Re: Agenda Item #: 4.b. Ordinance Bill 15-23

Salem Transportation System Plan Amendment Testimony

MAP APPENDIX

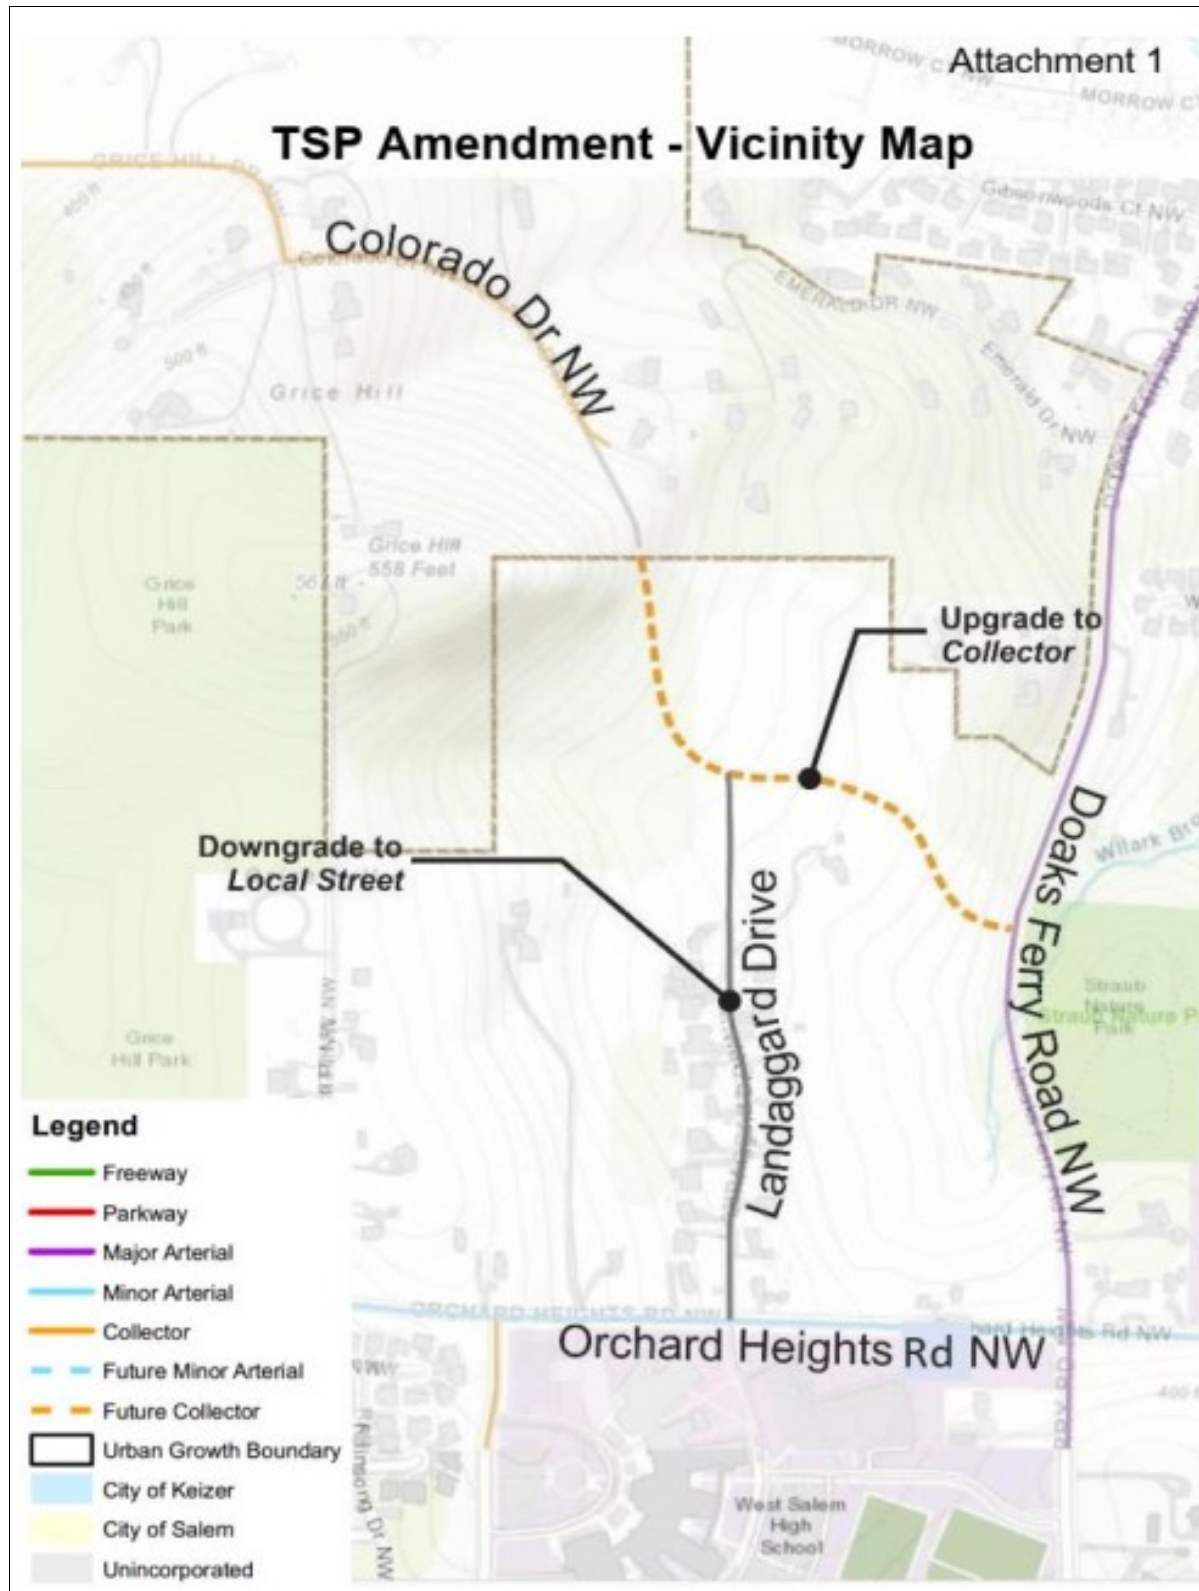
4. What is the logic of the revised Salem TSP that bisects Tax Lot 500 in such a manner that the northwest corner of that tax lot is isolated from the remaining bulk of Tax Lot 500? Since Salem roadways create new tax lot boundaries, what will happen to the narrow strip of land, approximately 36-feet wide depicted below, in Tax Lot 500 east of Colorado Drive once Colorado is angled southward into TL 500 and subsequently eastward into TL 400 (Titan Hill)?

5. How will the proposed Salem TSP modification implement the transition between the current Colorado Drive 68-foot R-O-W and the proposed TL 400 (Titan Hill) Colorado Drive 60-foot R-O-W?
6. Under what circumstances may the City of Salem adopt and/or modify the Salem TSP that approves a collector street alignment that does not meet Federal ADA transportation facility requirements?

Figure 1. Enlarged segment of Proposed TSP Amendment – Vicinity Map

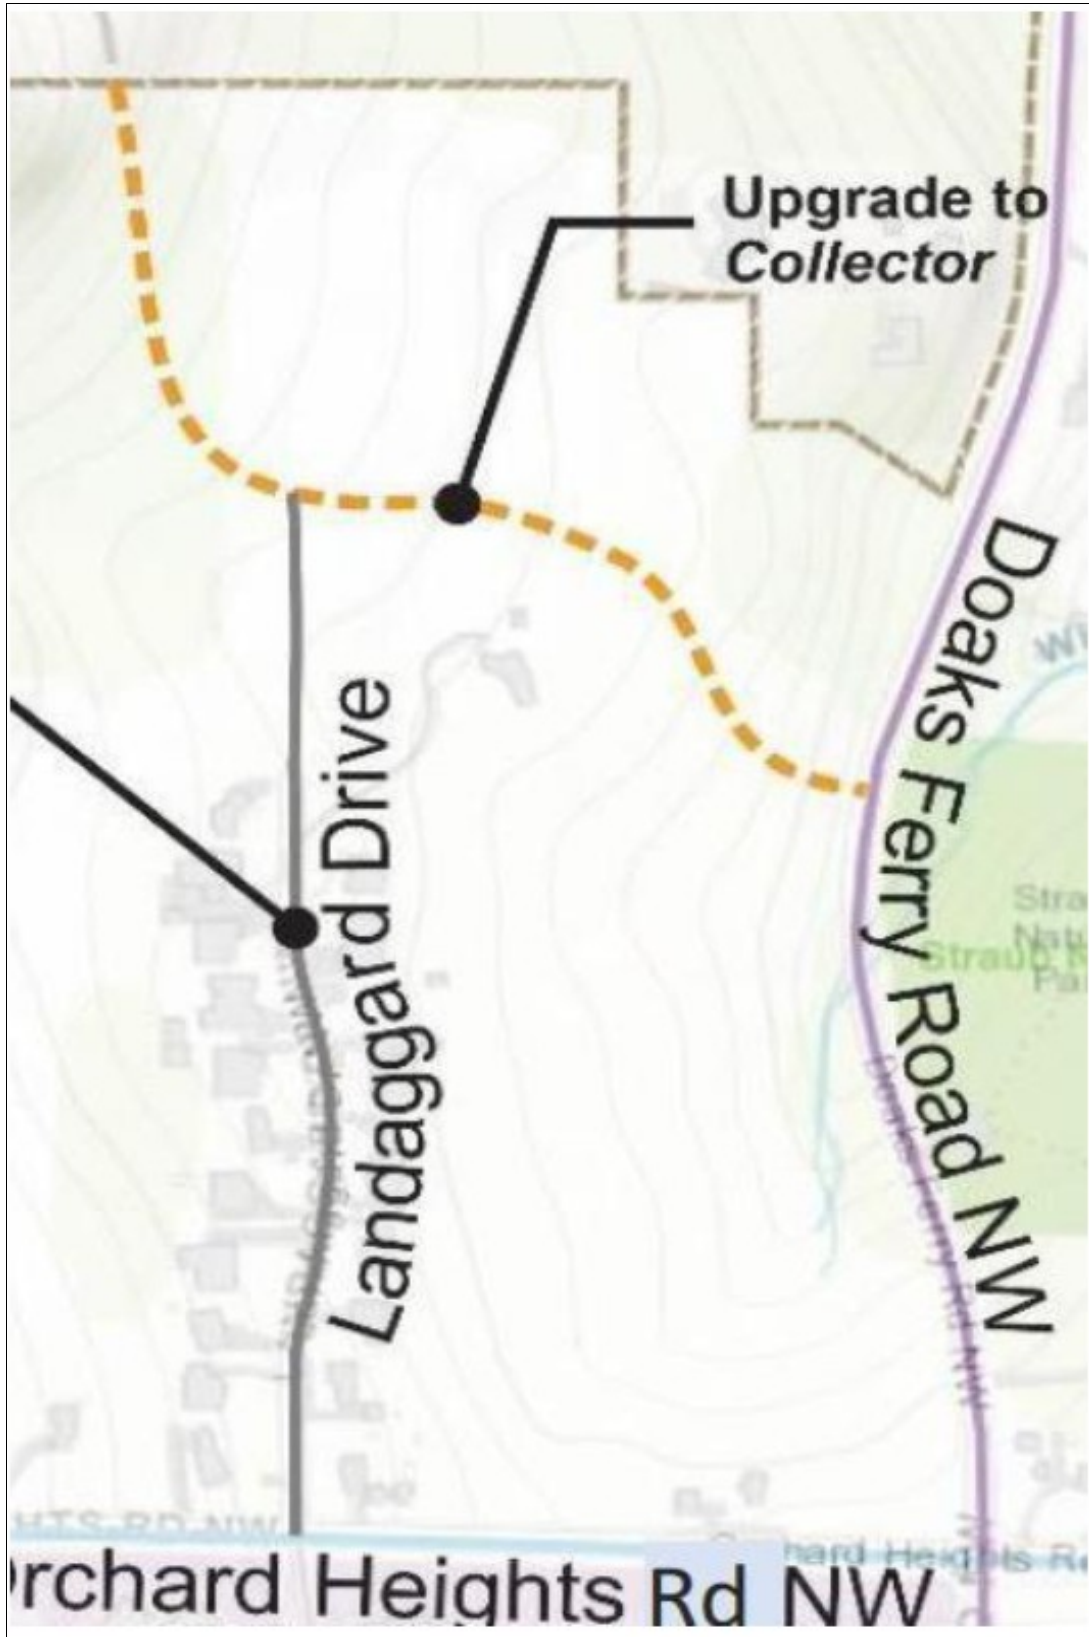
I challenge the Attachment 1 **Vicinity Map** graphic on page 1 for the following reasons.

1. It falsely shows the local street Landaggard Drive extending to the proposed Colorado Drive link (orange dashed line) to Doaks Ferry Road. See and compare Map Appendix Figures 1 and 2,
2. It incorrectly claims Landaggard Drive needs to be downgraded to a local street status.
3. It offers a projected Colorado Drive alignment that does not match street “A” (Map Appendix Figure 6) and fails to meet the 8 percent maximum required by both Federal ADA rules¹ and the Salem Revised Code².

Figure 3. Red line Colorado 8% Alignment on a Polk County ESRI Graphic

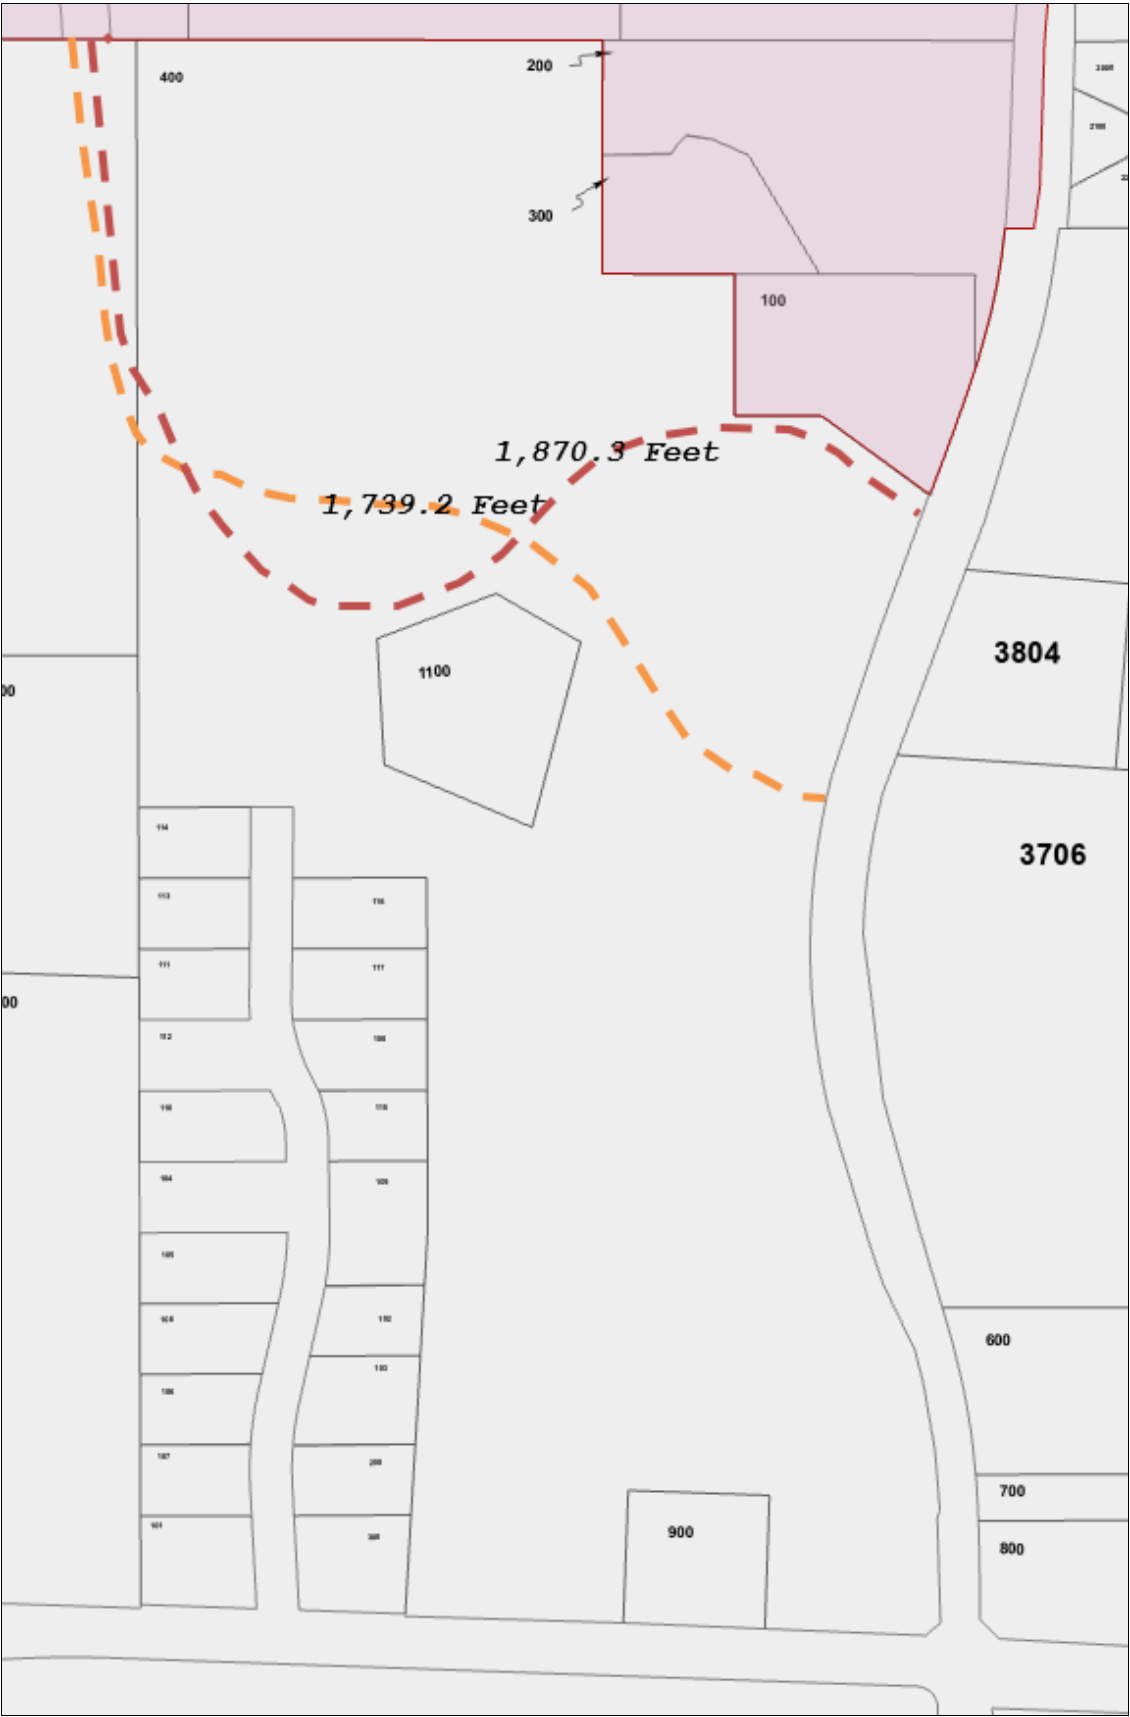
The dashed red dashed line on Map Appendix Figure 3 page offers an eight percent or less Colorado grade to Doaks Ferry Road and the blue dashed line on Map Appendix Figure 5 shows a less than 8 percent grade to Orchard Heights Road.

Figure 4. Blue line Colorado 8% Alignment on a Polk County ESRI Graphic

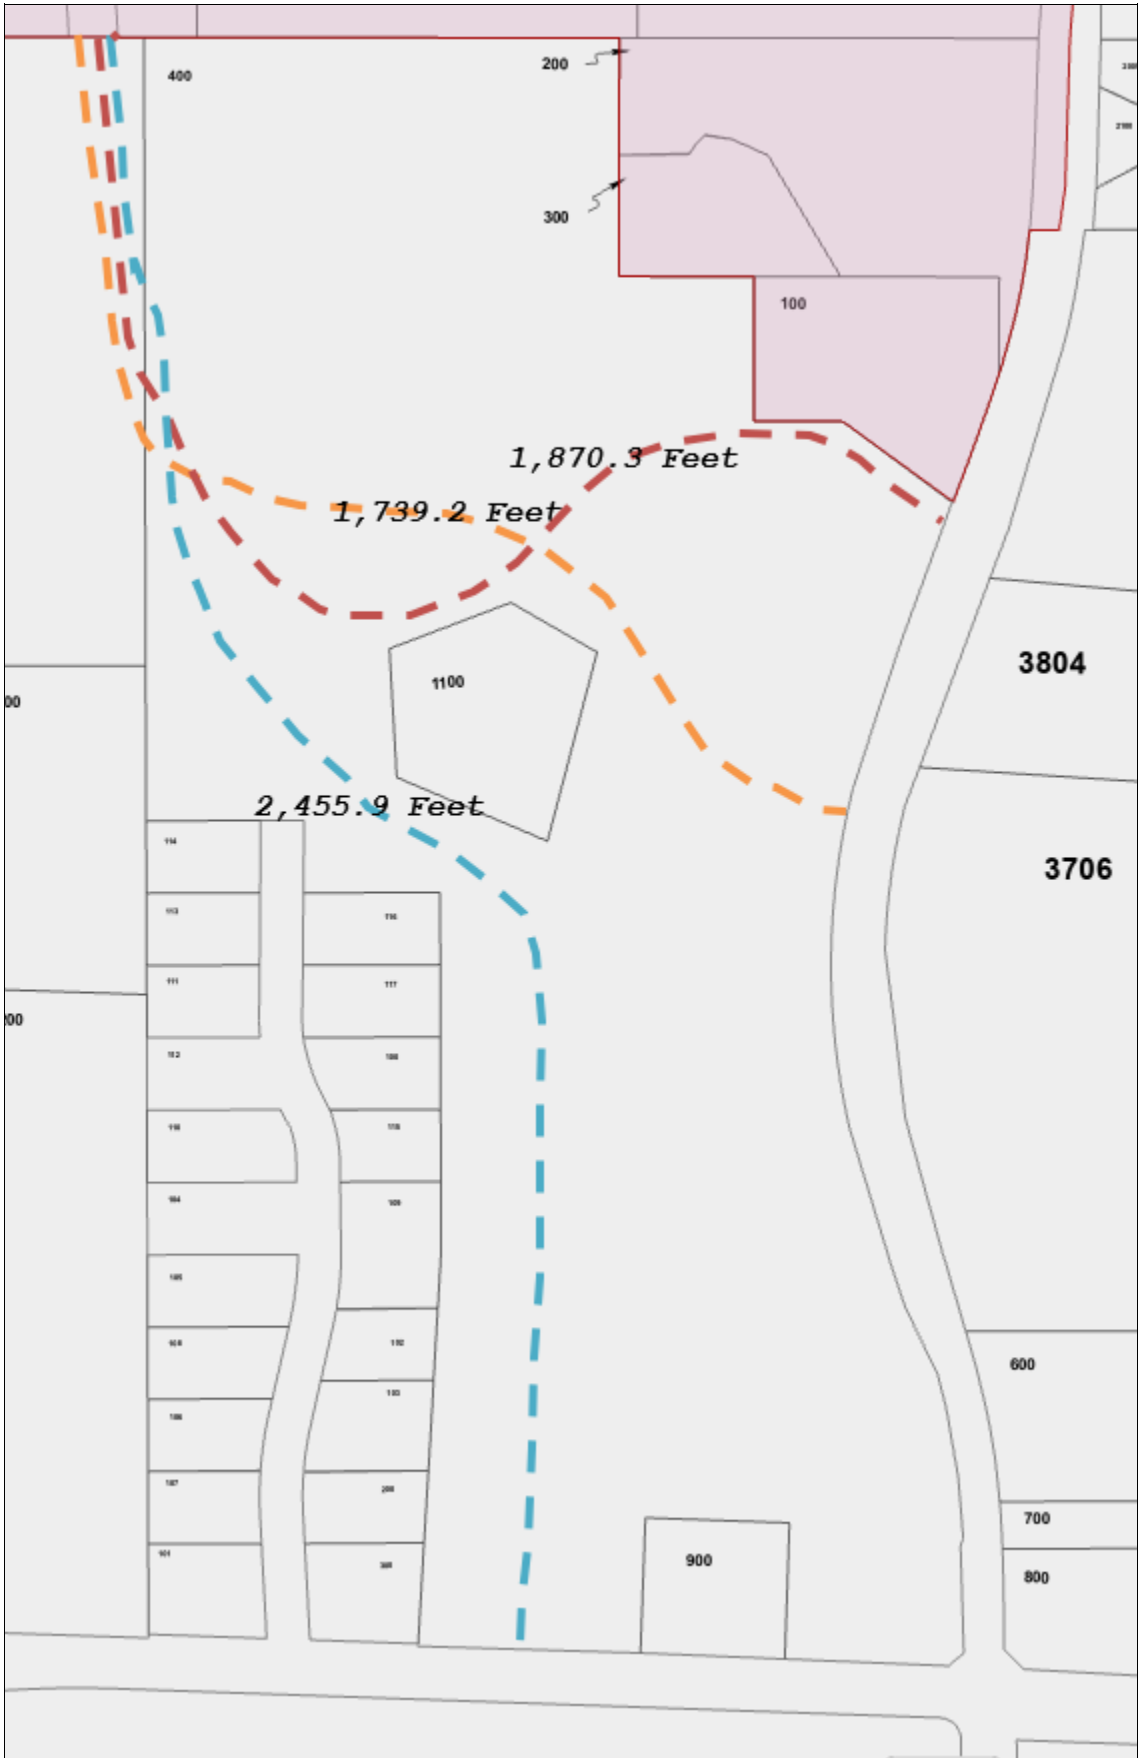
First, to assume that the only possible Colorado alignment to Orchard Heights Road is via Landaggard Drive is inaccurate. The dashed blue line Figure 4 offers an alternative connection between Colorado and Orchard Heights that is not considered in the materials submitted to Council.

Tentatively Approved Titan Hill Subdivision Proposed Colorado Drive Conflicting Alignments

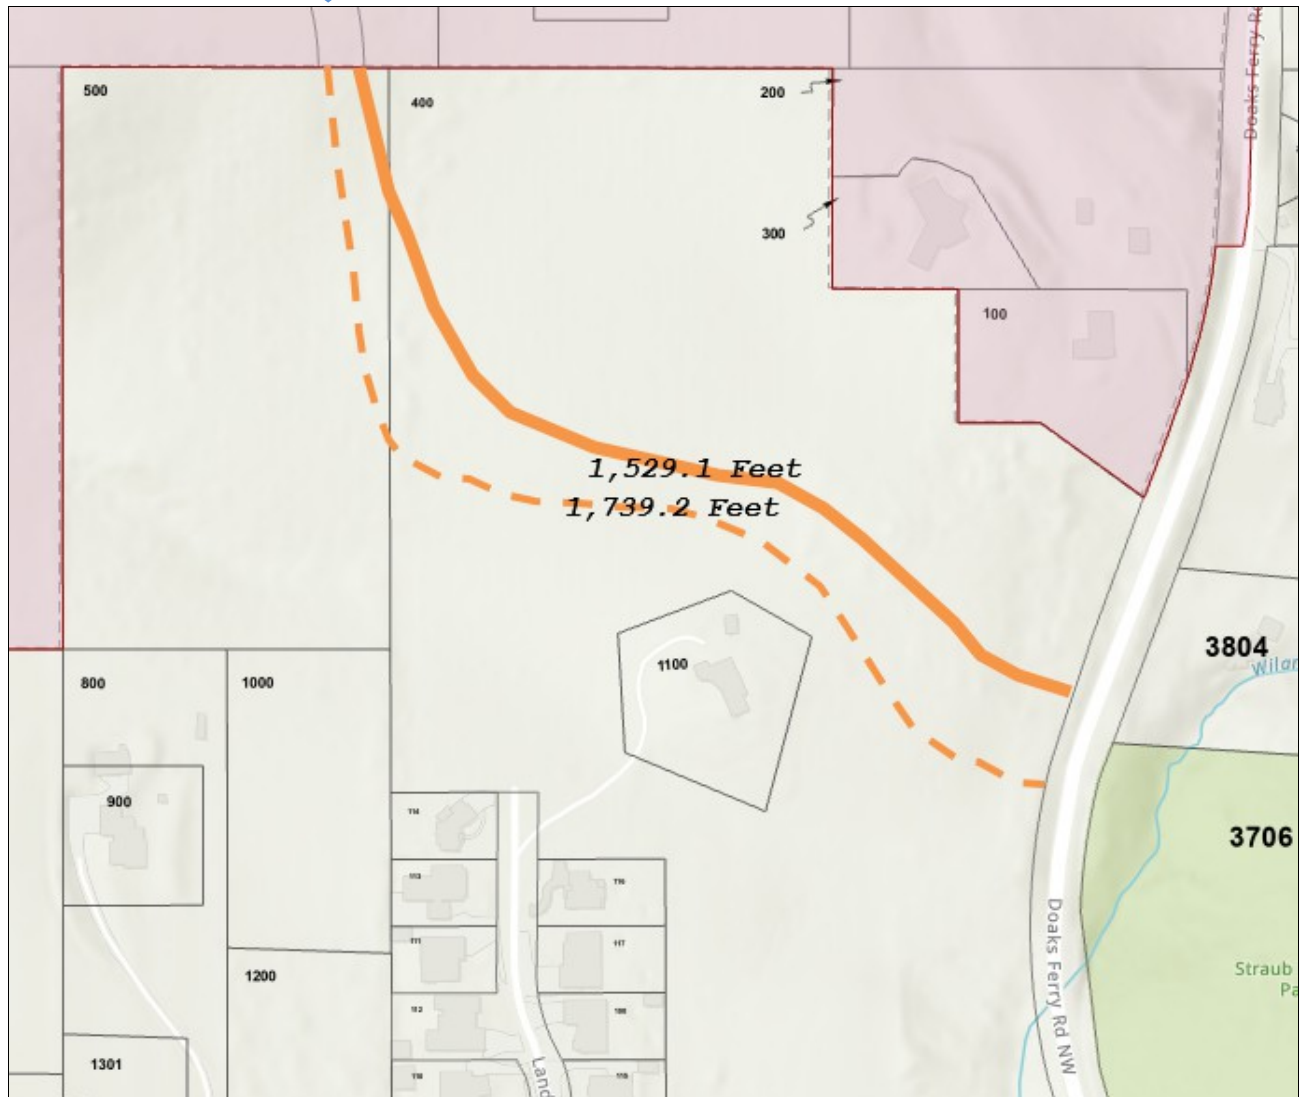
Solid Orange Line – Approximate alignment of Street “A” in the tentatively approved Titan Hill Subdivision. See Map Appendix Figure 6.

Dashed Orange Line – Approximate alignment of the future collector street Colorado Drive shown on **TSP Amendment - Vicinity Map**. See Map Appendix Figure 1.

- Which one of the two alignments will the Council's approval of the Salem Transportation System Plan (TSP) amendment becomes the actual approved Colorado Drive alignment?
- Will the approved alignment meet all Salem TSP legal requirements?

Figure 6

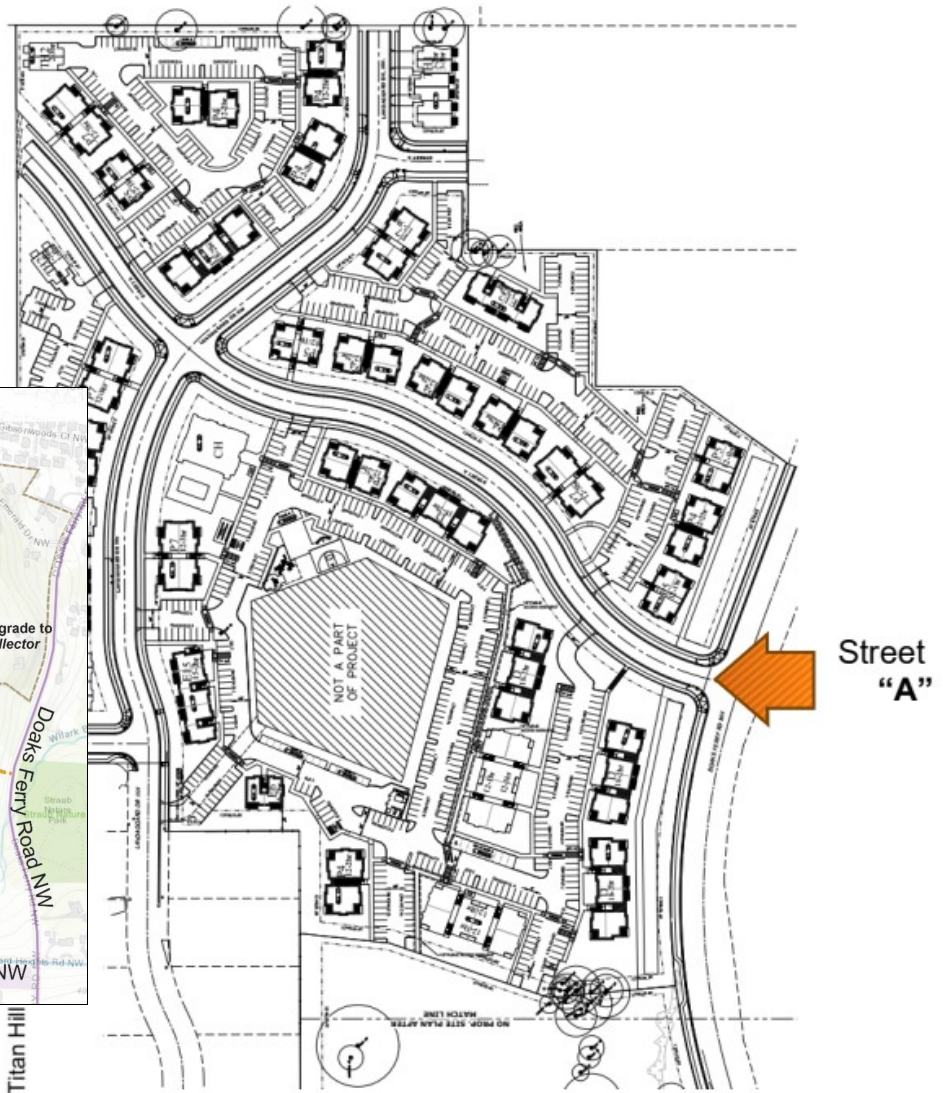
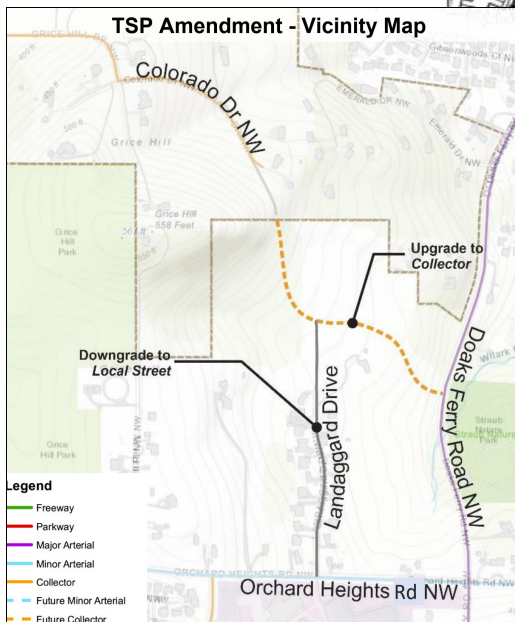
Note: Street "A" does not connect to the surveyed but not built Colorado Drive which terminates at the northern border of TL 500.

Note: The Titan Hill development is responsible for JUST the construction of Street "A" / Colorado Drive up to the border of Tax Lot 500. When and who will be responsible for completing the final connection to Colorado Drive remains unanswered.
